SUBJECT: ISSUANCE OF AMENDMENT FOR THE WASHINGTON PUBLIC POWER SUPPLY SYSTEM
NUCLEAR PROJECT NO. 2 (TAC NO. M88329)

The Commission is issuing the enclosed Amendment No. 123 to Facility Operating License No. NPF-21 for WPPSS Nuclear Project No. 2. The amendment addresses upgrading the analog main steam line (MSL) radiation monitors to digital monitors in response to your November 30, 1993, amendment request.

SAFETY EVALUATION BY THE OFFICE OF NUCLEAR REACTOR REGULATION
RELATED TO AMENDMENT NO. 123 TO FACILITY OPERATING LICENSE NO. NPF-21
WASHINGTON PUBLIC POWER SUPPLY SYSTEM
NUCLEAR PROJECT NO. 2
DOCKET NO. 50-397

Figure 1. NUMAC-LRM functional block diagram

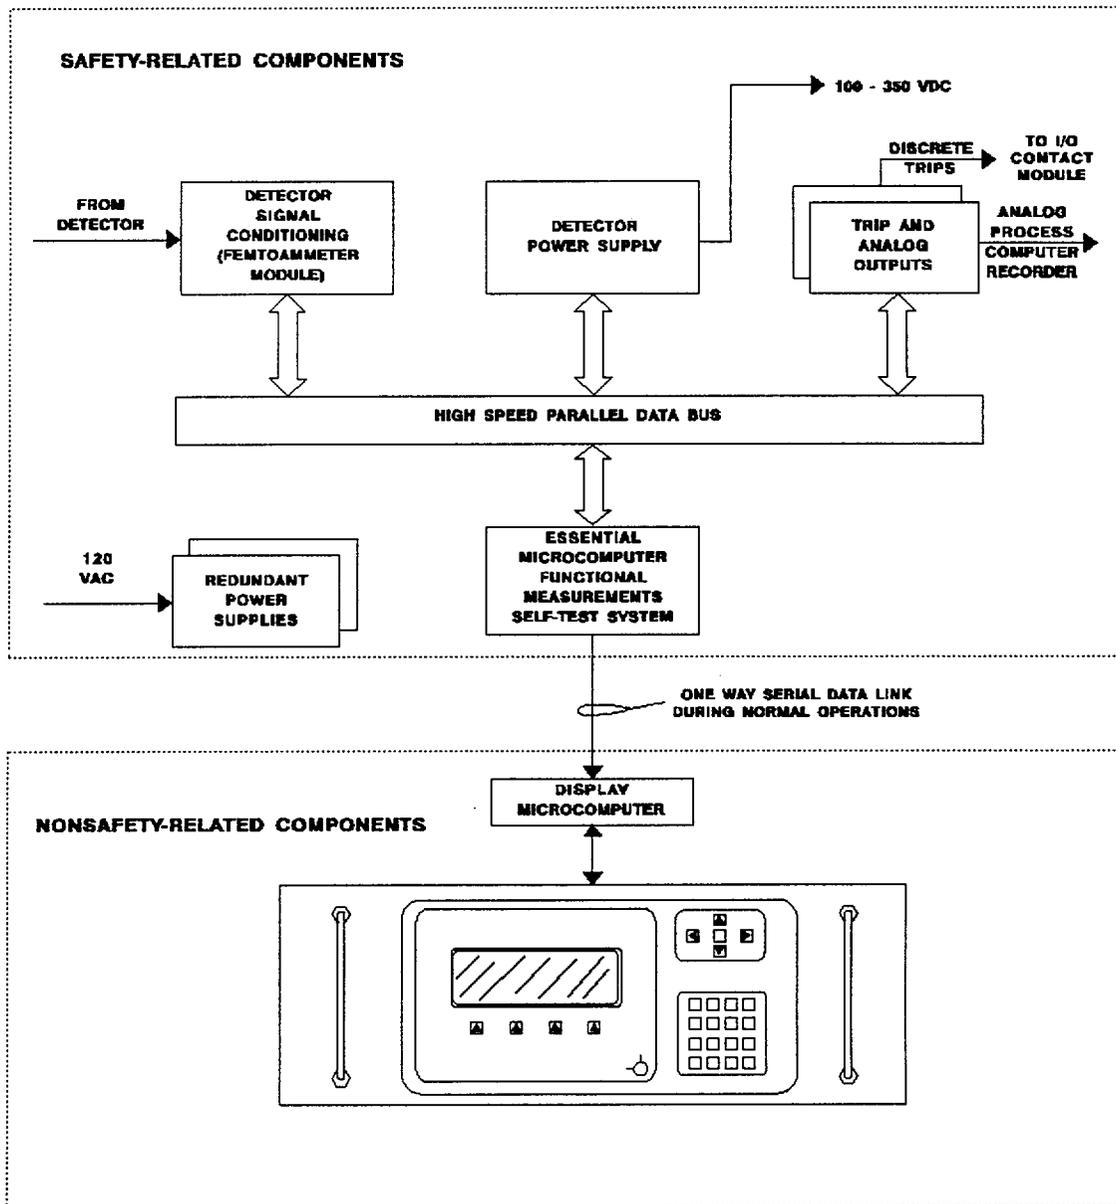
Figure 1 shows a NUMAC-LRM functional block diagram. The safety-related

portion of the NUMAC-LRM consists of four channels of the following components:

The detector signal conditioning (DSC) module in each monitoring channel receives femtoamp-magnitude input signals from its associated gamma-sensitive ion chamber. The ion chamber is mounted near the main steam outlet piping. The DSC processes the detector current signals into corresponding millirem per hour (mR/hr) signals. It also transmits the mR/hr signals to the essential microcomputer via an RS-485 serial connection and a signal splitter. The essential microcomputer, using a Harris 80C86 microprocessor, converts the mR/hr signals into control signals. The control signals are then transmitted to the other modules within the chassis using a high-speed parallel data bus. The essential microprocessor also transmits the signals to the display microprocessor/front panel display over an RS 232 serial data link. The essential microcomputer also performs self-test system diagnostics when not processing instrument data. The self-test feature has a lower processing priority than the safety features. Consequently, the self-diagnostic routines are automatically exited when a higher priority signal requires processing. This assures the essential microprocessor will perform the safety-related tasks in the shortest possible time.

A femtoammeter amplifier transmits three trip circuit signals (HI-HI, HI and LO) to the essential computer. The essential computer processes the input trip current signals and produces independent output trip voltage signals for the input-output (I/O) contact module. Operators can preset the trip circuits to trip at any desired limit. A fourth trip circuit signal (INOP-HVPS) actuates on any of the following inoperability indicators:
